Addendum No. 3

September 10, 2021

Project: San Fernando Regional Park Infiltration Project

**Attachment 4: Revisions to Diversion Pipe Plan and
Profile from Glenoaks Boulevard**

DWG No.
C-02

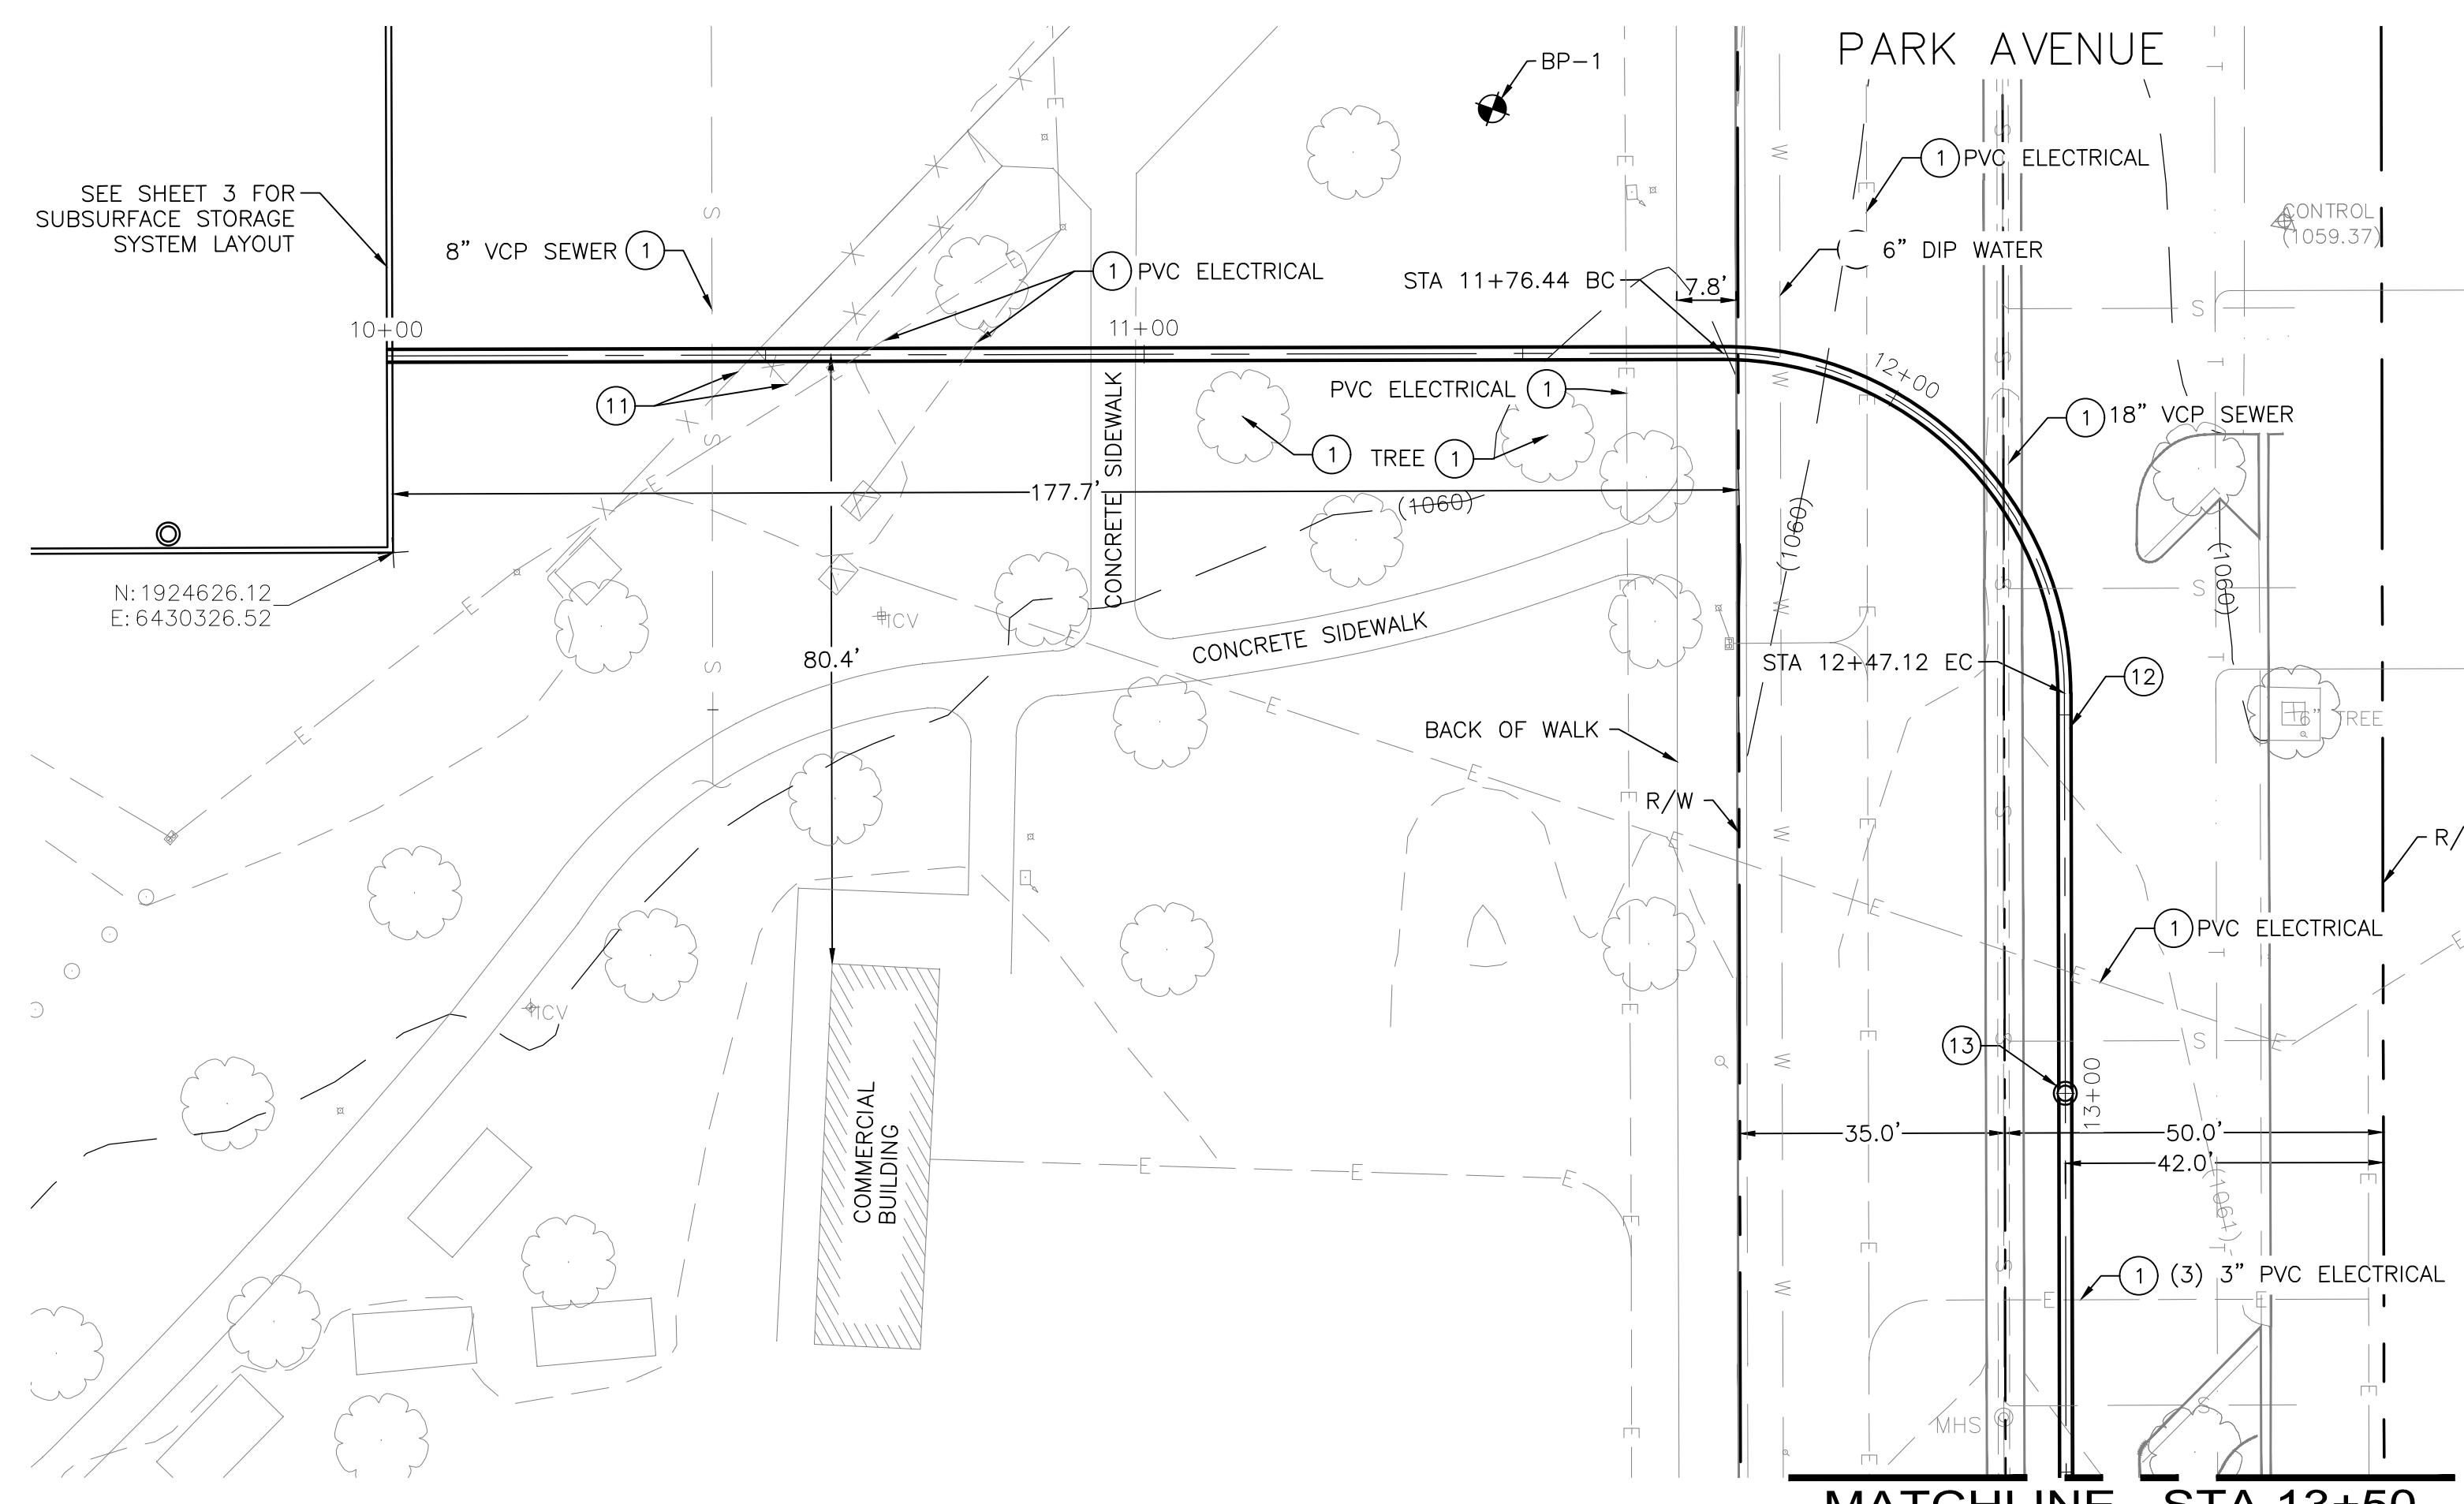
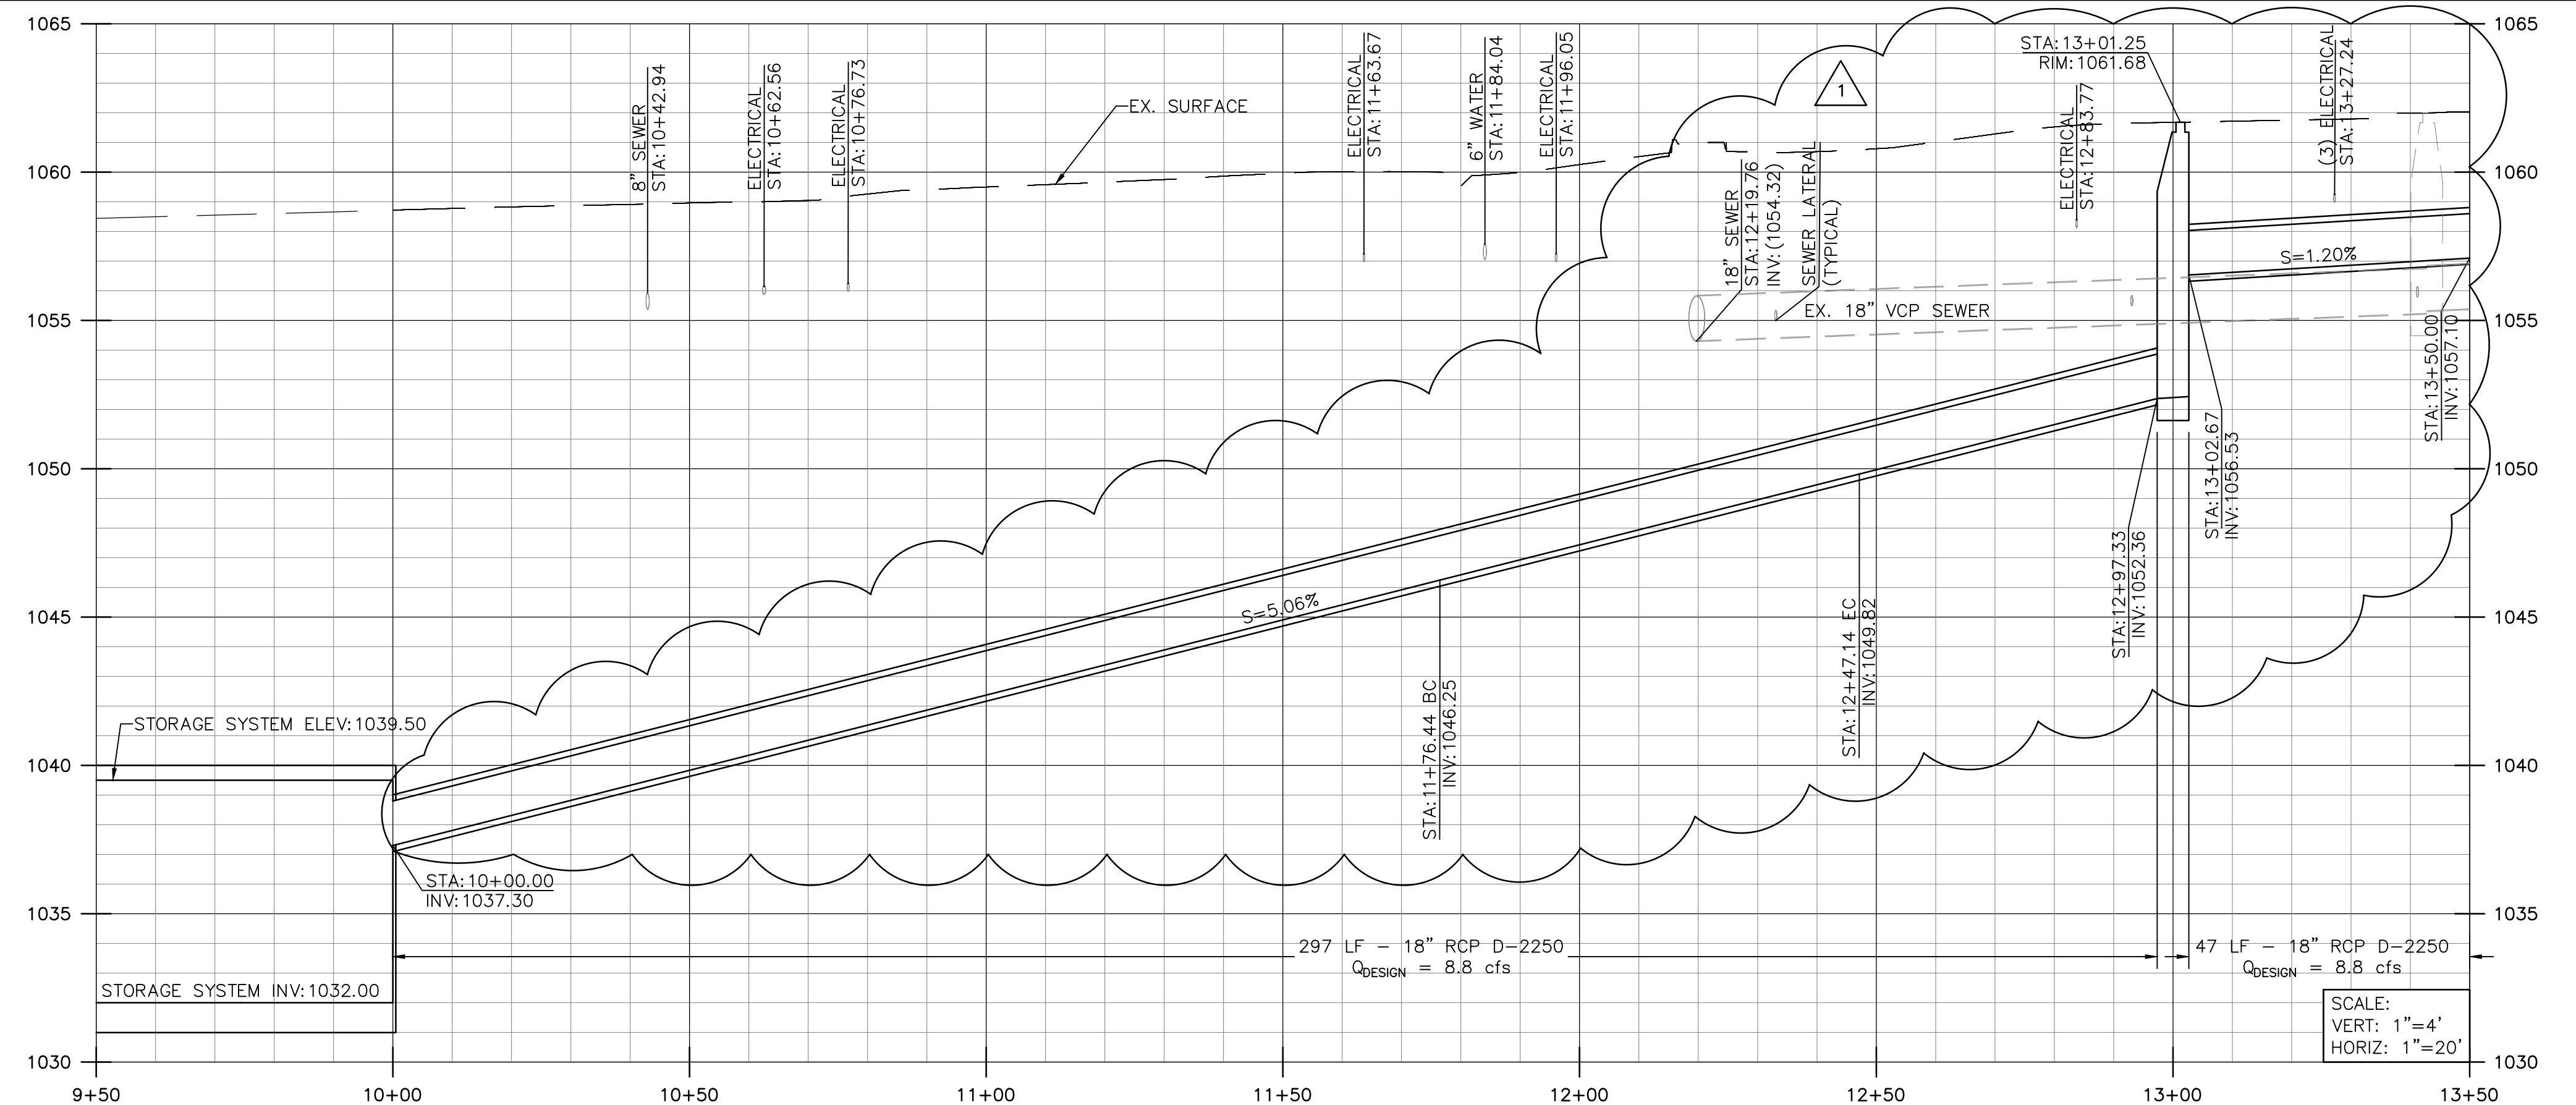
Question #45: Sheet C-02 called for the contractor to locate then support or replace 2 sewer lines that are interfering with the infiltration system. For bidding purposes, what is the requirement for replacing these sewer lines (pipe type, pipe size, bedding, etc.). Please provide tie-in locations for these lines.

Answer #45: The exact alignment and service extent of the sewer lines shown on Sheet C-02 and C-18 are to be confirmed by the Contractor. The sewer lines labeled on Sheet C-02 tie into the manhole shown on Sheet C-18. Site survey data suggests there are several connections at the manhole (labeled with rim elevation 1058.09 on Sheet C-18), while as-builts are not available and CCTV footage does not provide additional confirmation. It is anticipated that the sewer laterals are 6-8" VCP and if they are to be replaced, then they shall be replaced in kind with bedding as specified in Greenbook Section 306-6 and associated Special Provisions.

DWG NO.
C-04
SHEET NO.
5
OF
46

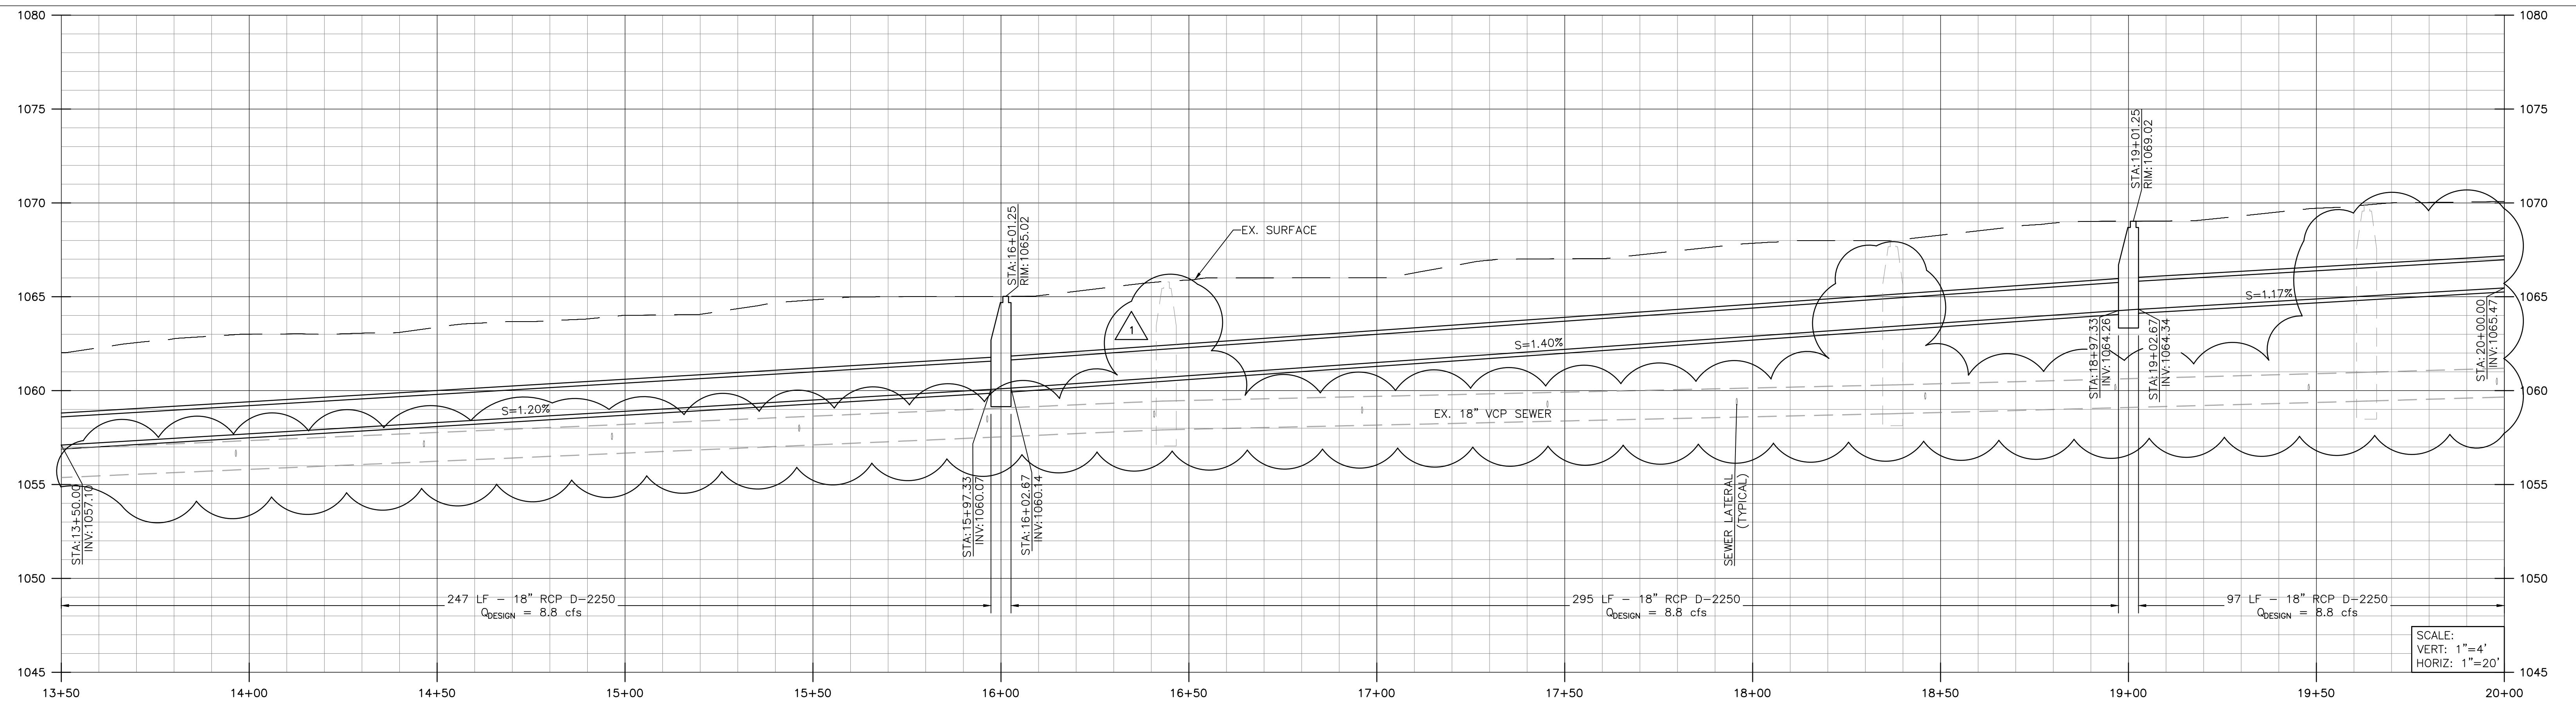
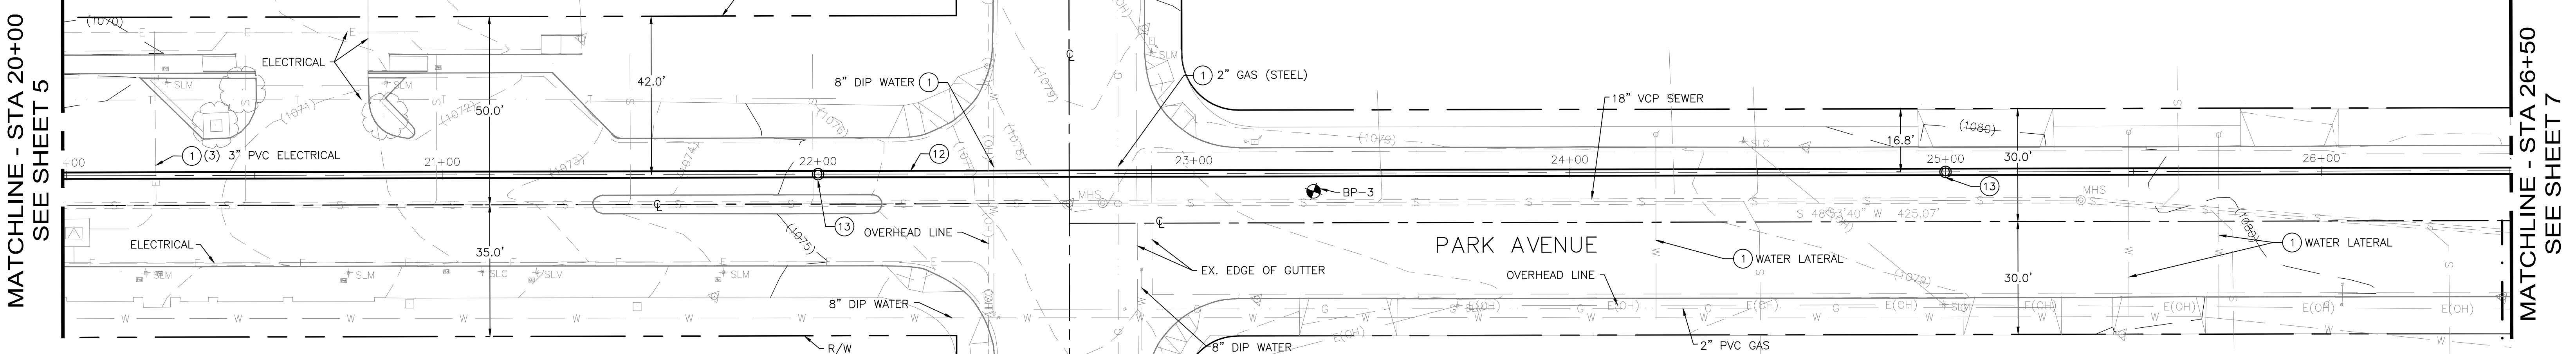
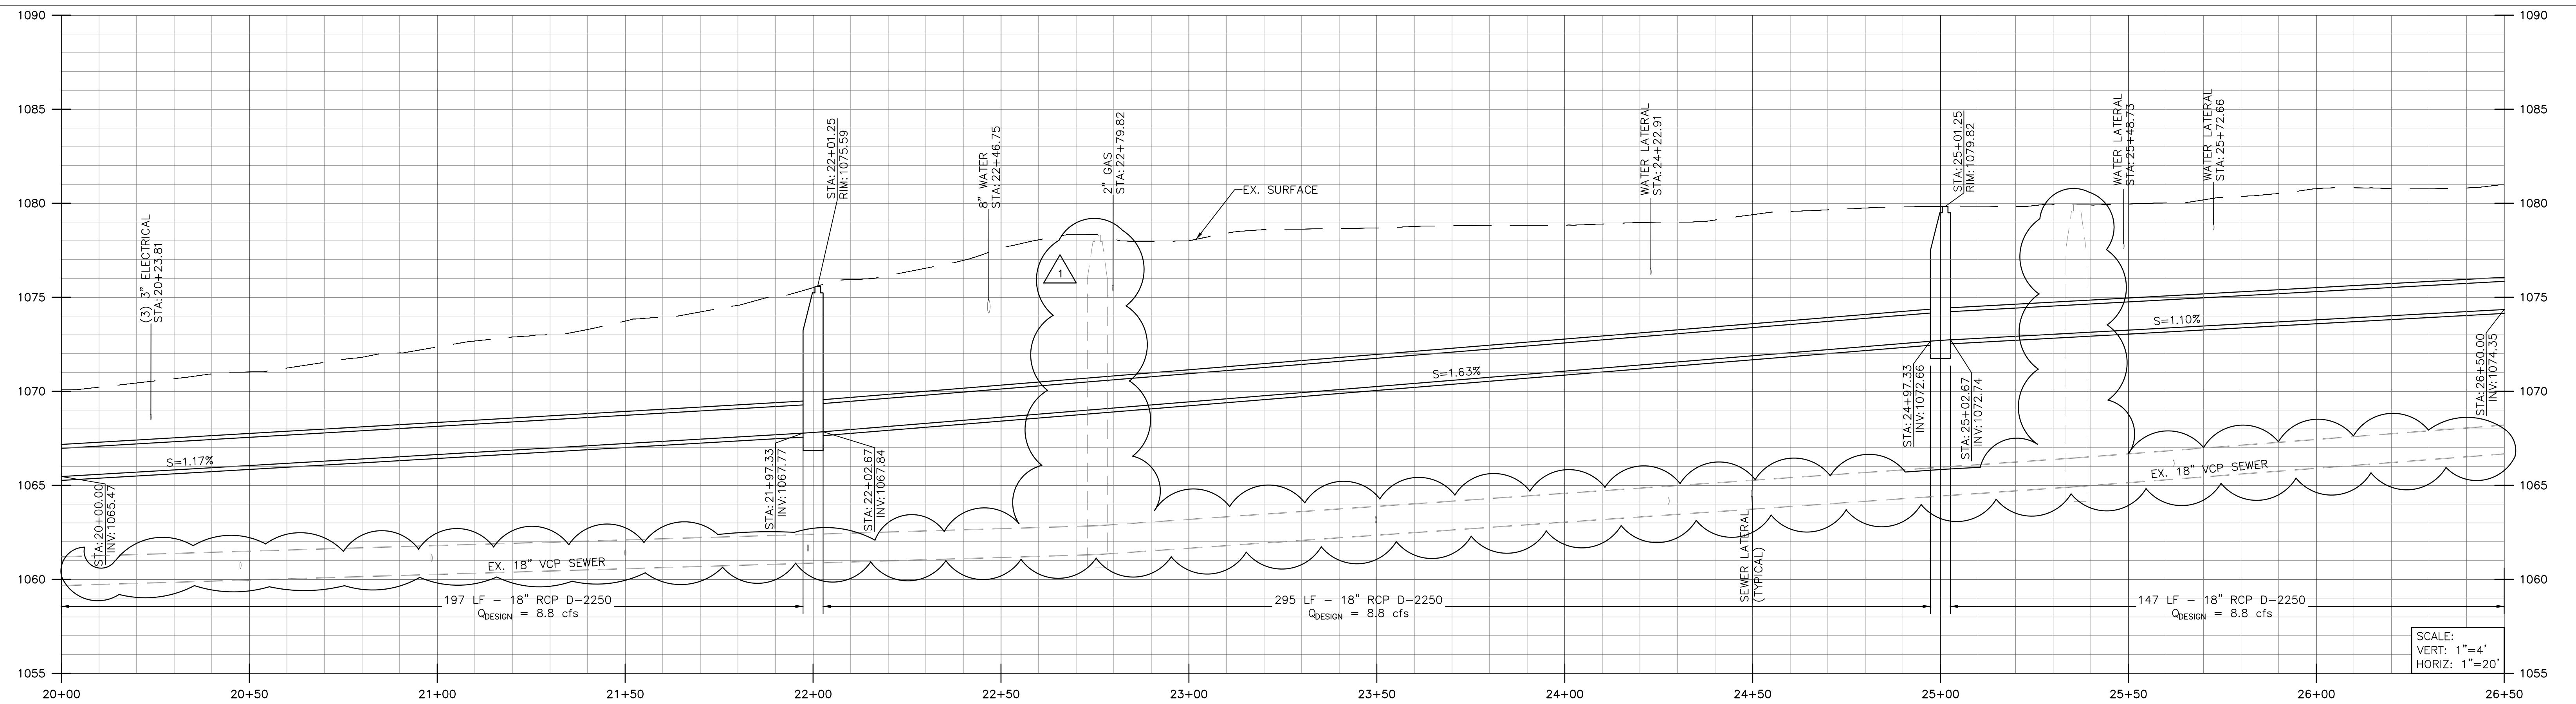
REV.	DATE	BY	DESCRIPTION	APP'D
1	9/7/21	TT	ADDED EX. SEWER LINE TO PROFILE; REVISED PIPE INVERT/SLOPE	
2	9/10/21	TT	ADDED HOUSE CONNECTION NOTE UNDER NOTES TO CONTRACTOR
